TECHNICAL BULLETIN

[Issue No.] GOT-A-0040-A

[Title] Change to the Option Function Board Interface (for the MES Interface Function) of the GT16 Models
(Handling of the Great East Japan Earthquake)

[Relevant Models] GOT1000 Series (GT16 Models)

2. How to identify the temporary GOT

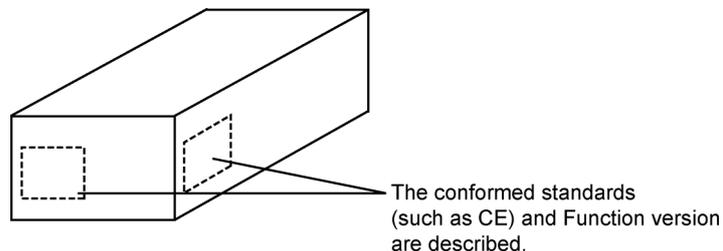
Function version C or D applies to the temporary GOT.

You can also check the function version with the labels on the GOT packing box. The positions of the labels differ depending on the model and the shipment date.

3. Difference between the temporary GOT and the conventional GOT

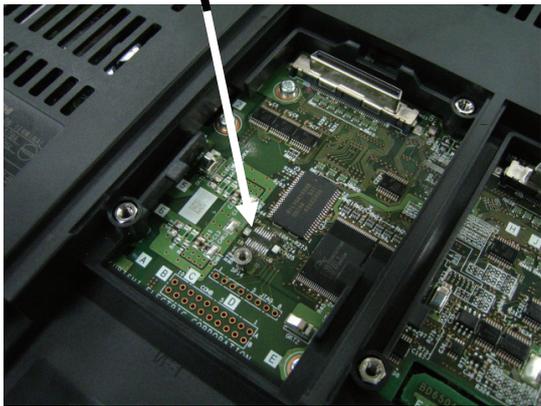
Since the temporary GOT does not have the connector of the option function board interface (for the MES interface function), you cannot mount an option function board on the GOT.

Though you cannot use the MES interface function with the temporary GOT, the other functions and the specifications do not differ between the temporary GOT and the conventional GOT.

The option function board interface (for the MES interface function) is located on the extension interface 1 side (the extension interface 2 side for the GT1655 only) on the GOT rear face without the extension unit cover.
